RE: ISFA Guaranteed Rate Field – Sound Room Cooling Project
Engineer's Project Number: 23504
Addendum Number: 01

This Addendum consists of additions and/or modifications to the plans and/or specifications to the bidding and contract documents dated January 23, 2025. The changes to these documents are only in the manner and to the extent stated herein. All drawings have “Issued for Addendum 1” and “01/31/2025” on the sheet. Changes are bubbled and tagged with revision Delta 1. This Addendum supersedes any oral or written information previously delivered. Contractor to acknowledge receipt of this Addendum 1 on the Bid Form; failure to do so may subject bidder to disqualification.

M1.306

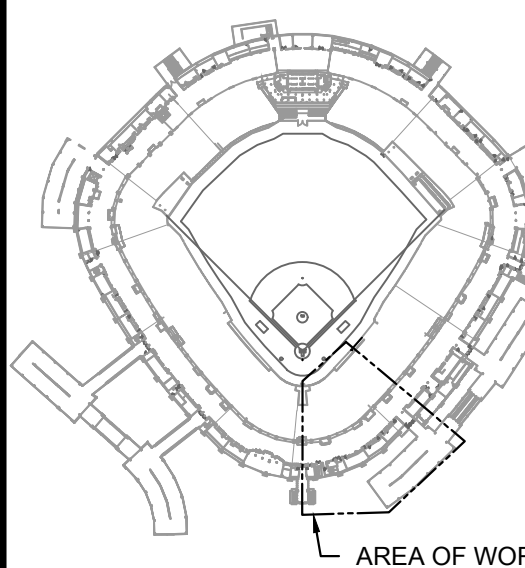
1. Sheet M1.306 – Mechanical Plan – Level 300 – Section 6
 - a. Revise locations of CU-D1, CU-D2, and CU-D3. Revise refrigerant pipe and control wiring routings as required.
2. Sheet E1.306 – Electrical Plan Plan – Level 300 – Section 6
 - a. Revise locations of CU-D1, CU-D2, and CU-D3. Revise power routings as required.
 - b. Revise location of new power receptacle.
3. Providing supplemental sketches for the Ground Level, 100 Level, 200 Level, and 300 Level, to define routing locations for new condensate drain piping. The Issued for Construction Set will incorporate these markups.

100 LEVEL

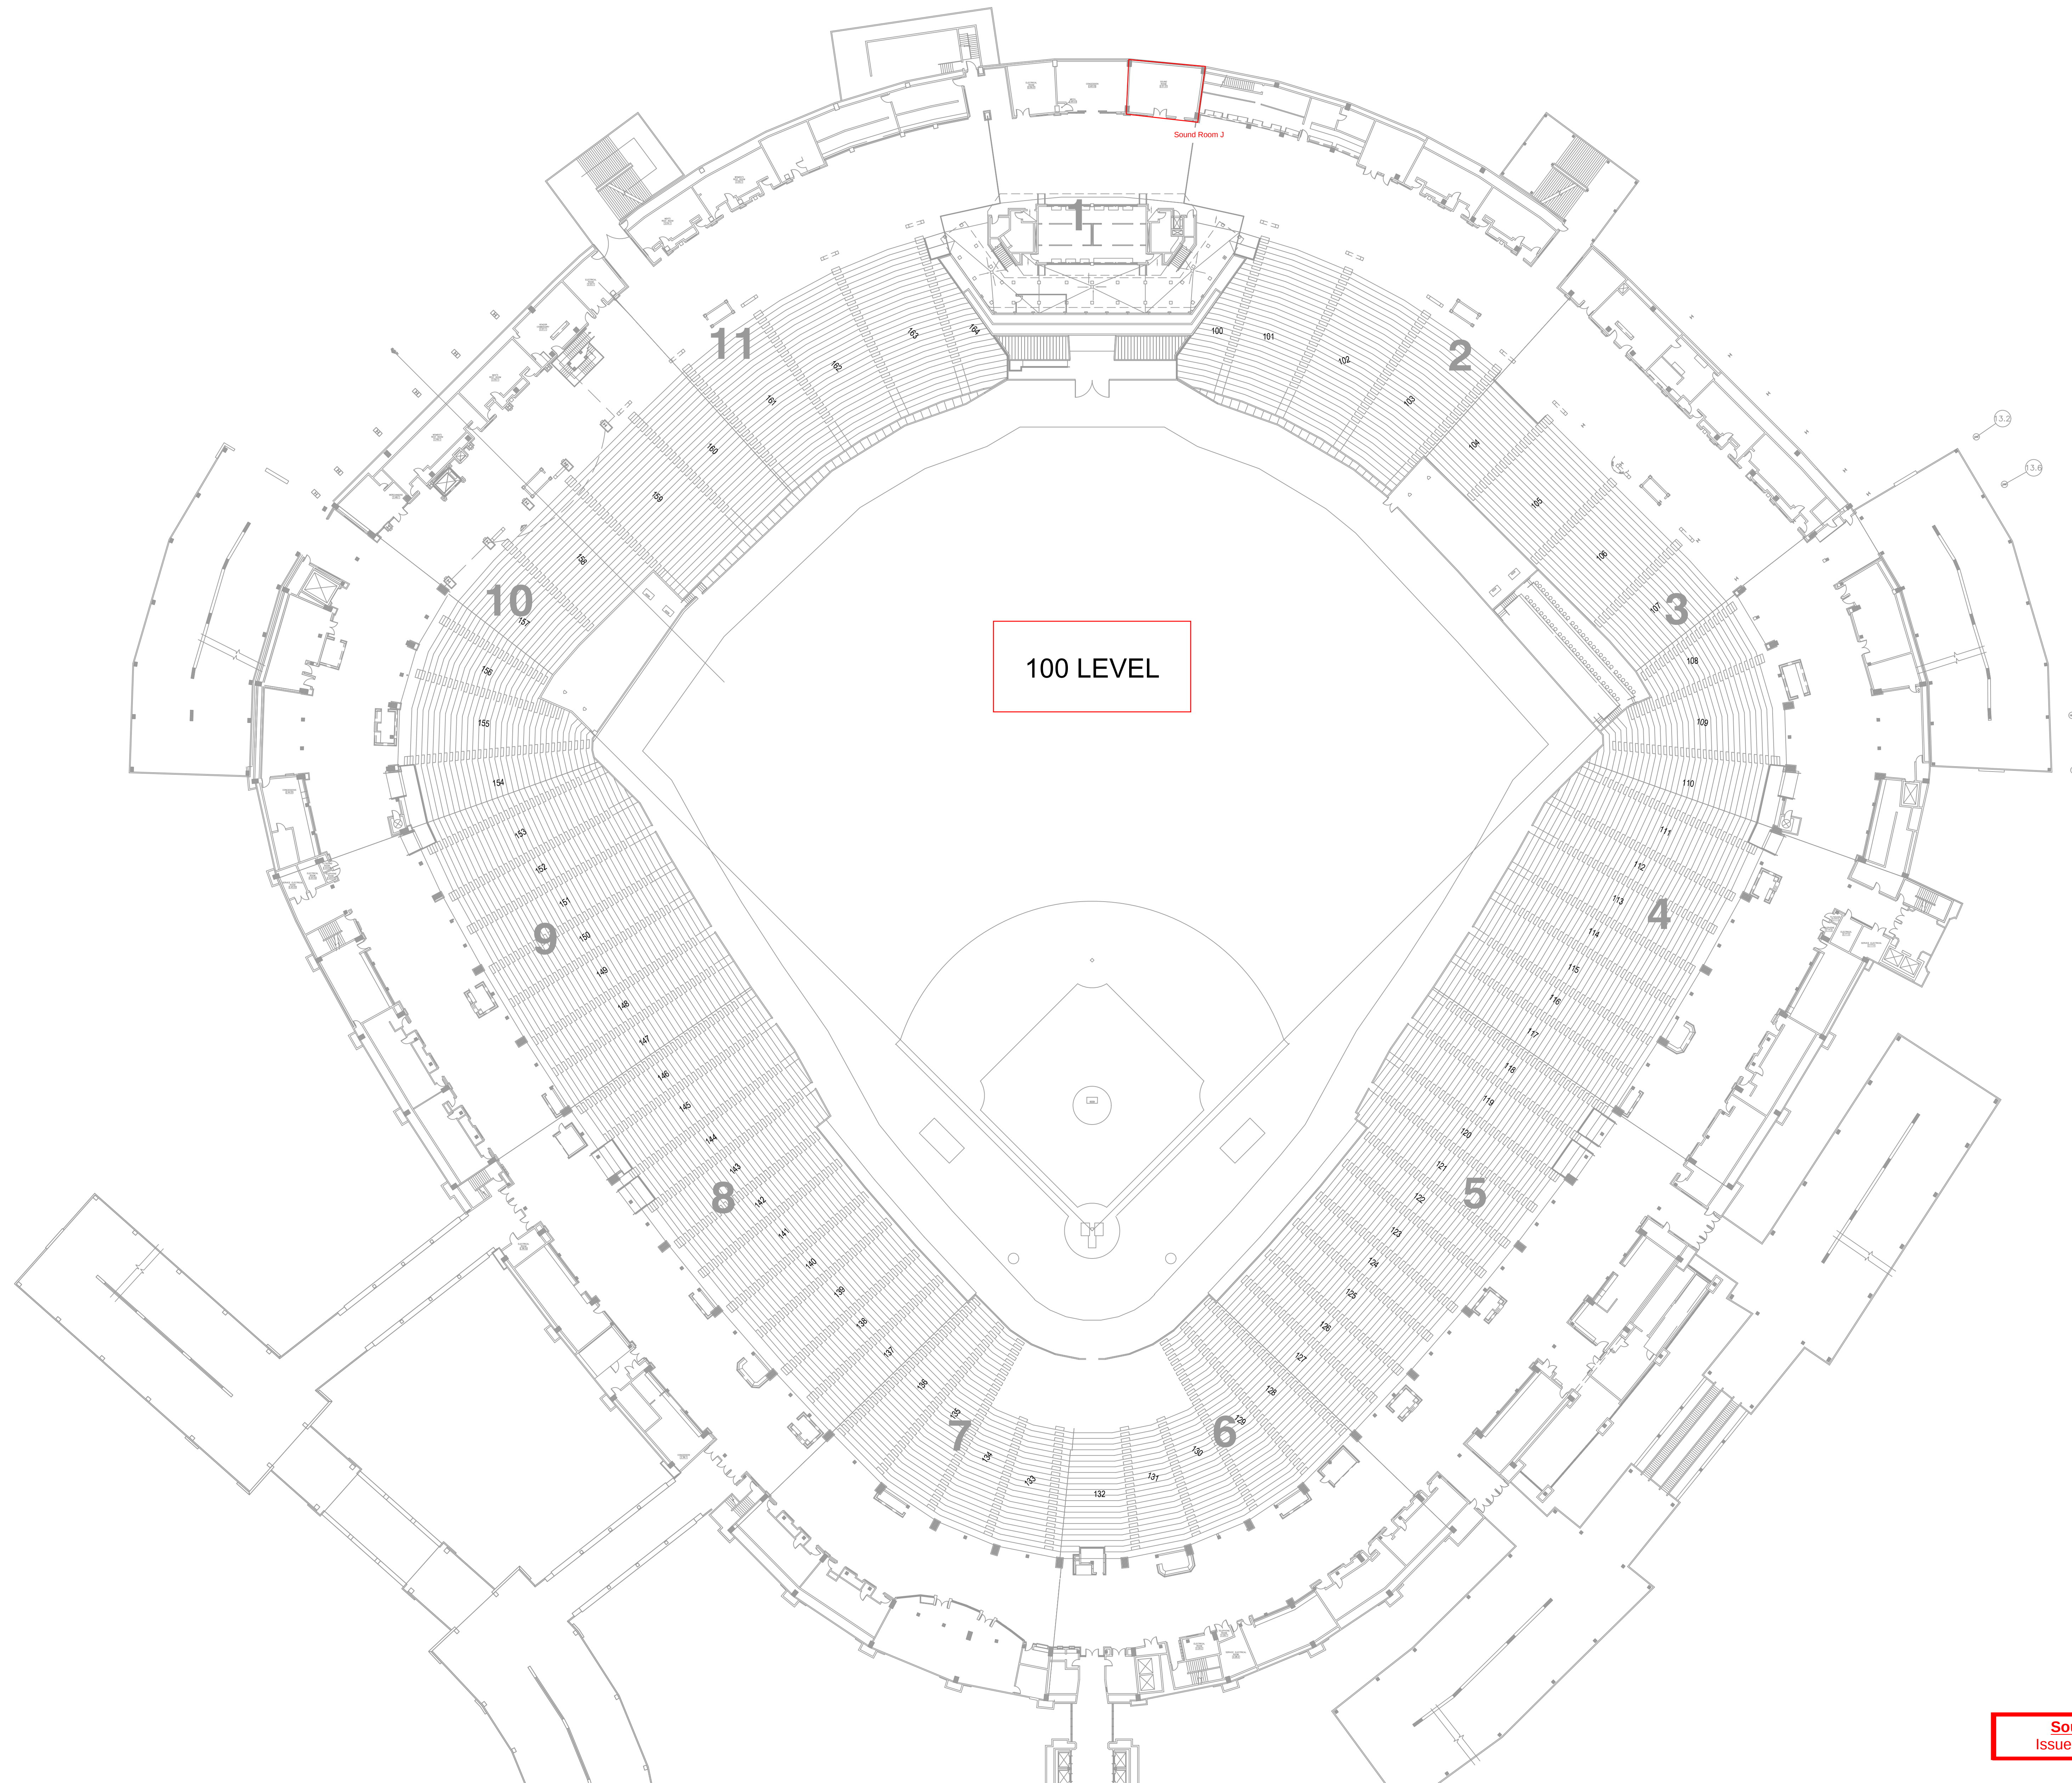
2. **Question:** The Condensate drains for all the units appear to go to a drain on floors lower than the floor with the IDF room on it. Do we increase the size of the existing drain all of the way to the open site drain it terminates in? **Answer:** Yes, the existing drain size is too small to accommodate the added cooling capacity. Increase the entire drain main to 1-1/4" and connect into where indicated on the attached sketches as part of this Addendum 1.

200 LEVEL

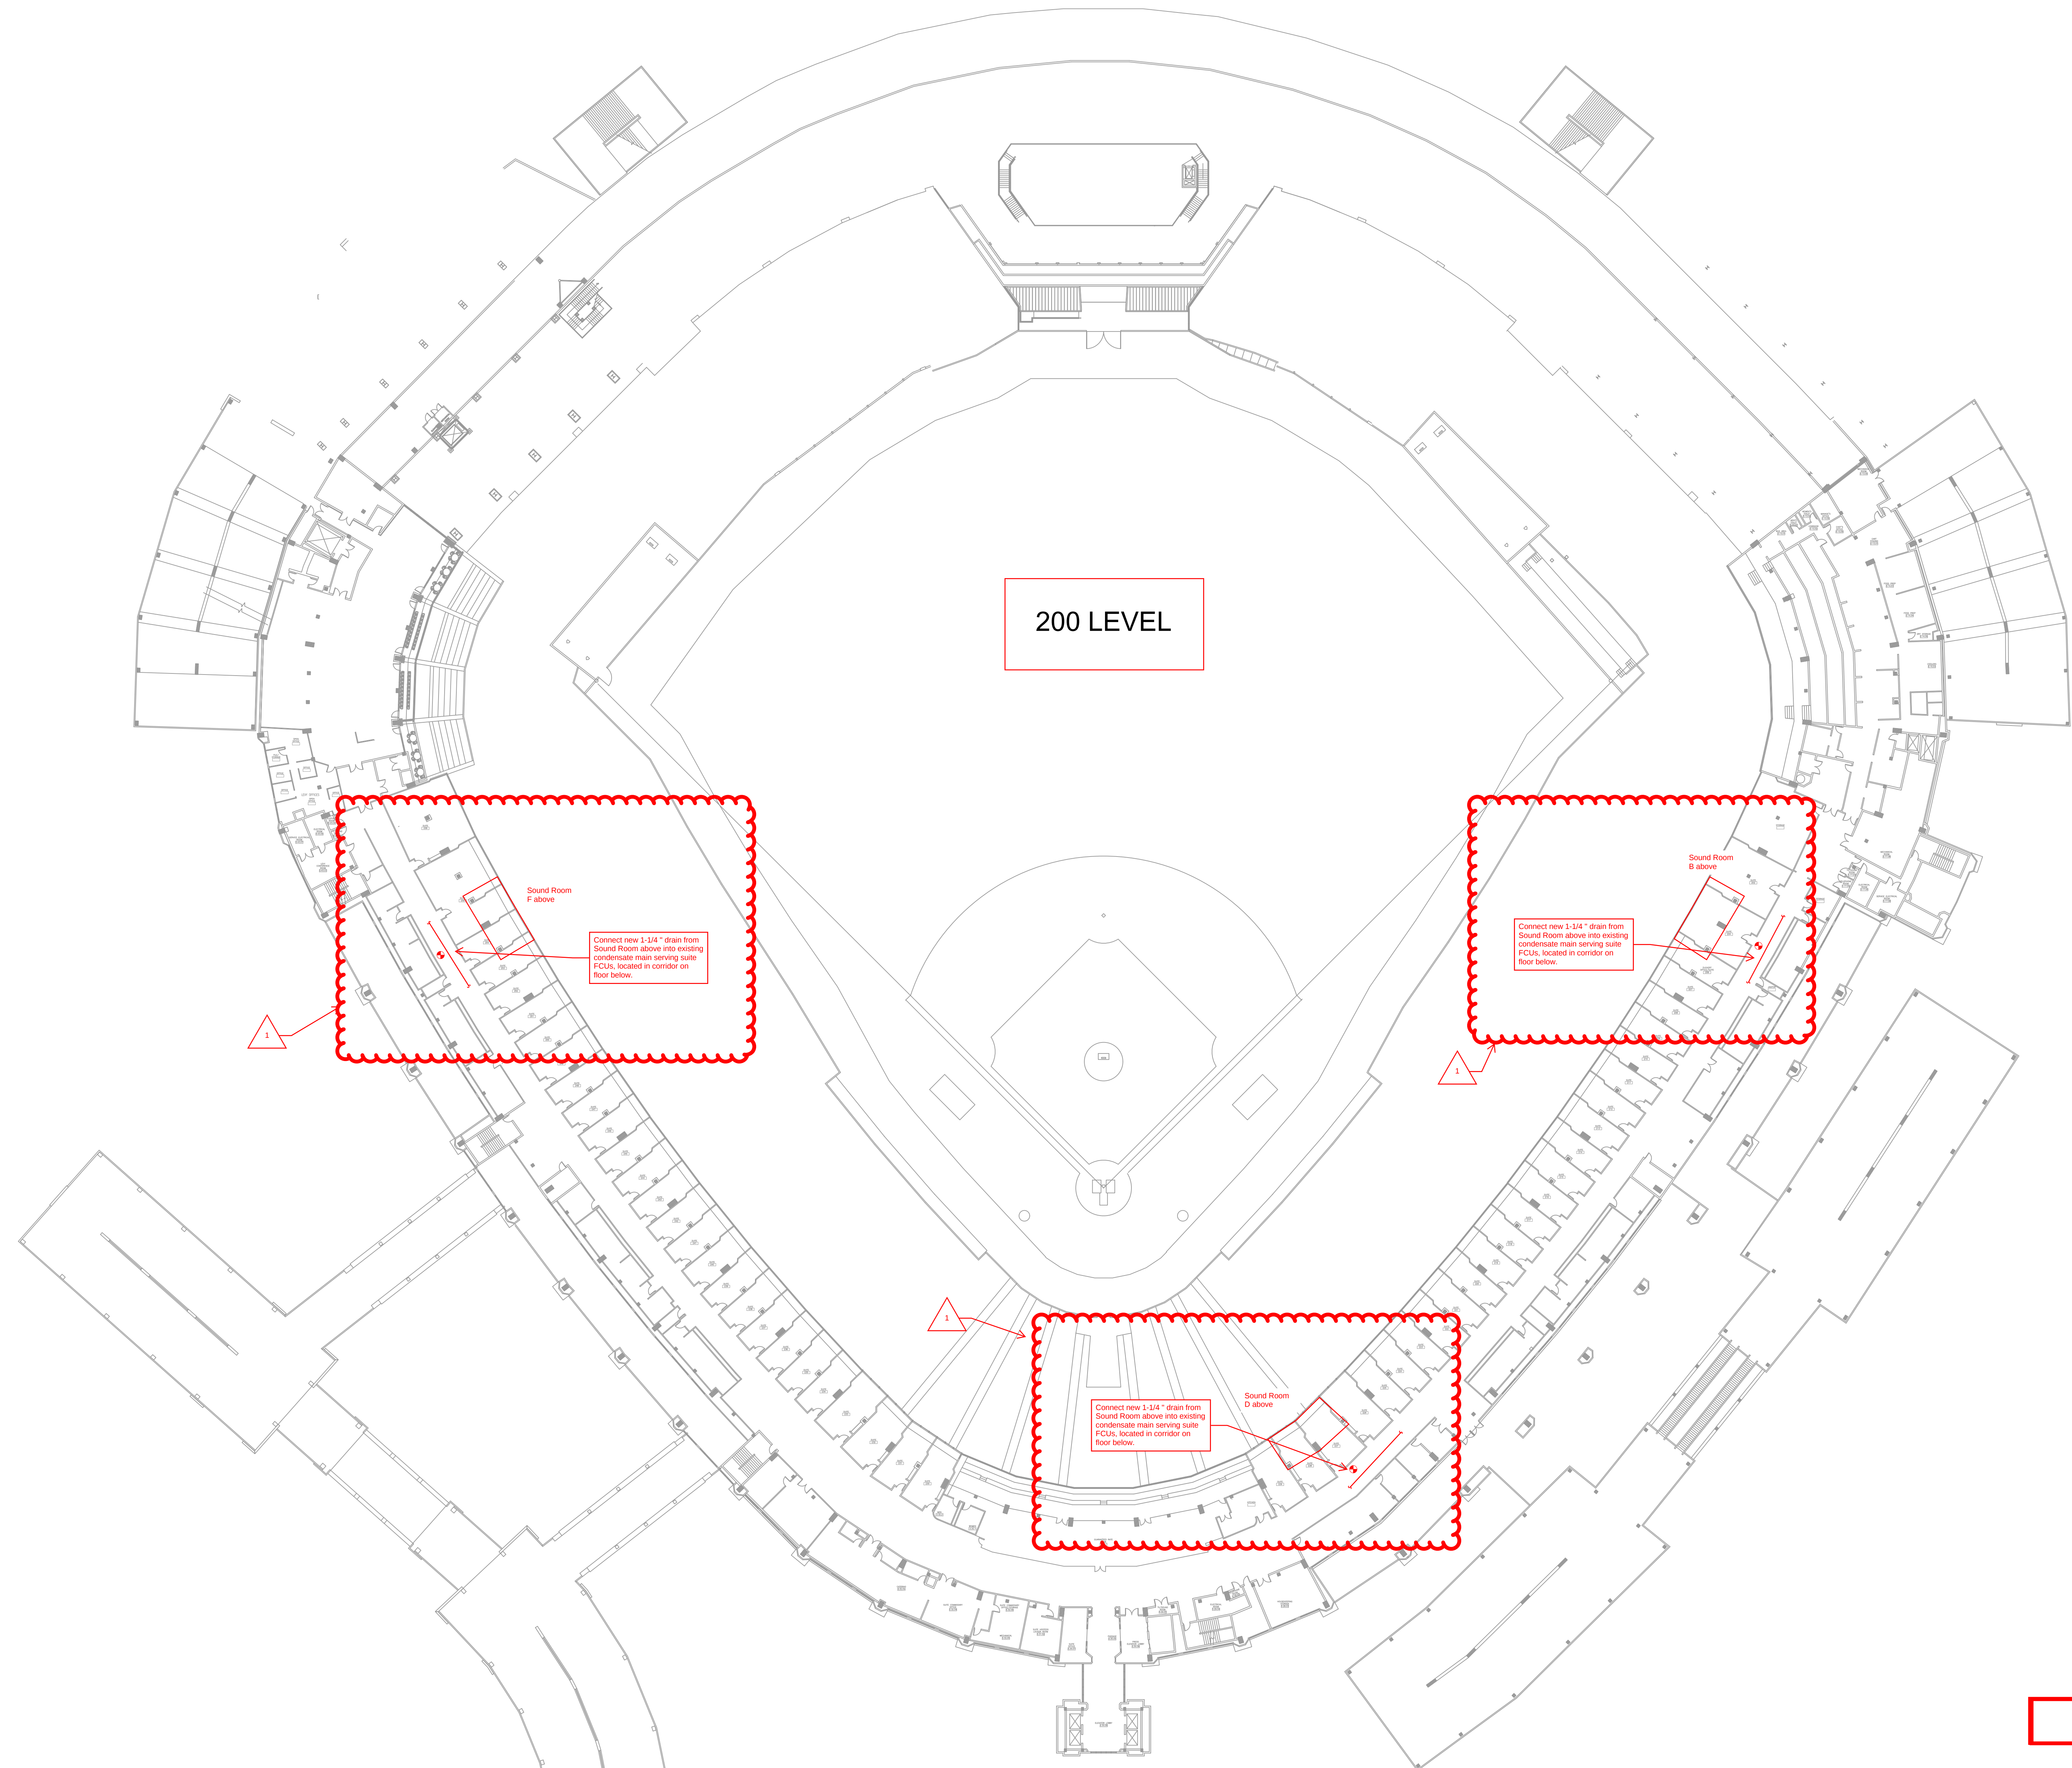
Connect new 1-1/4" drain from
Sound Room above into existing
condensate main serving suite
FCUs, located in corridor on
floor below.
